Your ref
APP/20/01000

Our ref
PLAN-036108

Proposal: Proposed single storey extension.

Site: APP/20/01000: - 11 Langbrook Close, Havant, PO9 1RS.

Screen Print

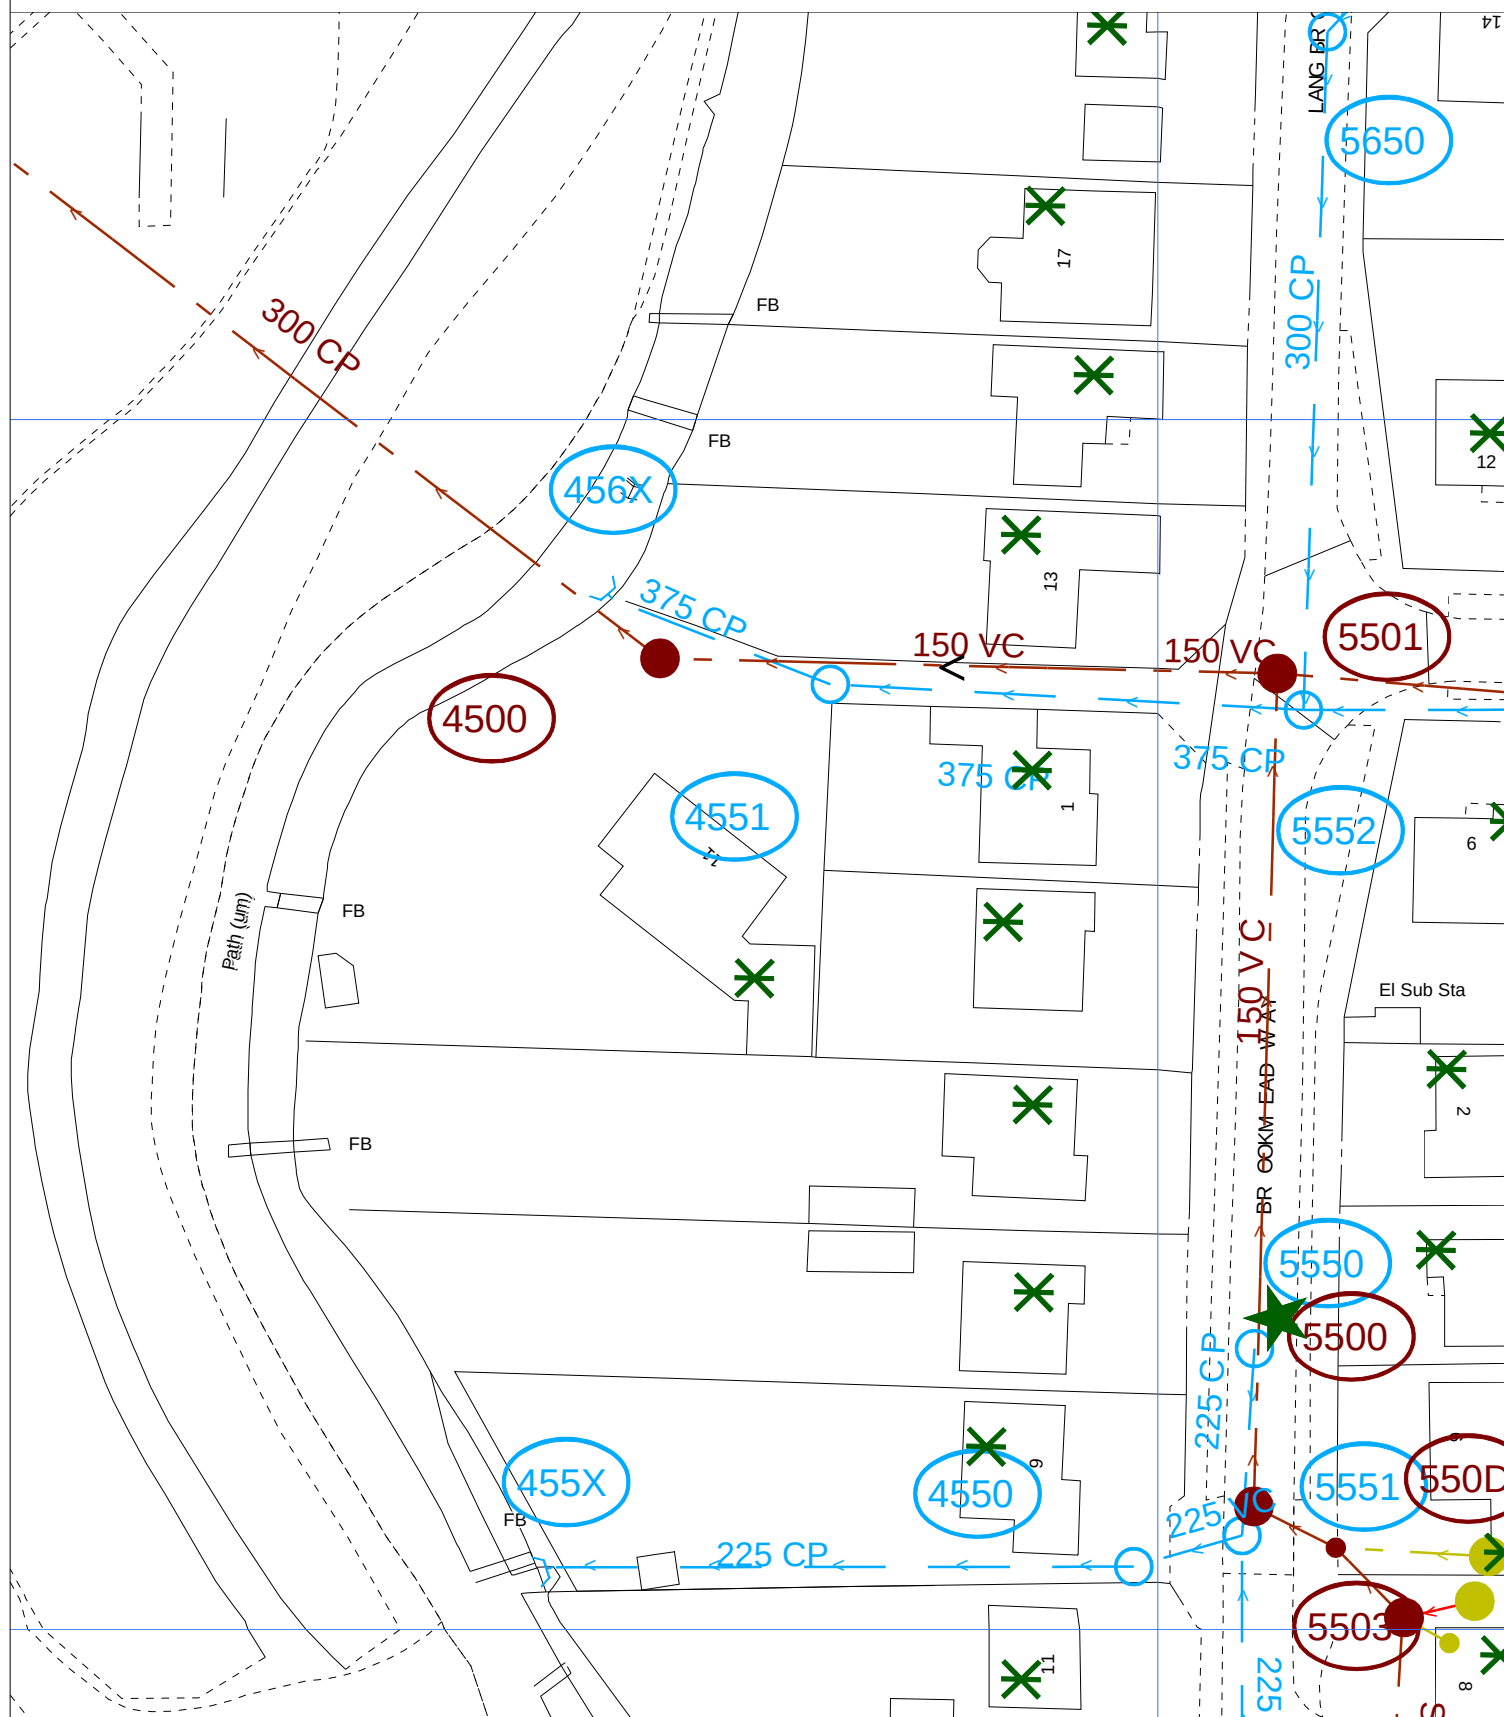
Please see the attached extract from Southern Water records showing the approximate position of our existing foul and surface water sewers within the site. The exact position of the public assets must be determined on site by the applicant.

- The 150 mm foul sewer and 375 mm surface water sewers requires a clearance of 3 metres on either side of the gravity sewers to protect it from construction works and to allow for future access for maintenance.
- No development or tree planting should be carried out within 3 metres of the external edge of the public gravity sewer without consent from Southern Water.
- No soakaways, swales, ponds, watercourses or any other surface water retaining or conveying features should be located within 5 metres of public sewers.
- All existing infrastructure should be protected during the course of construction works.

In order to protect public sewers, Southern Water requests that if consent is granted, the following condition is attached to the planning permission; The developer must agree with Southern Water, prior to commencement of the development, the measures to be taken to protect the public sewers.
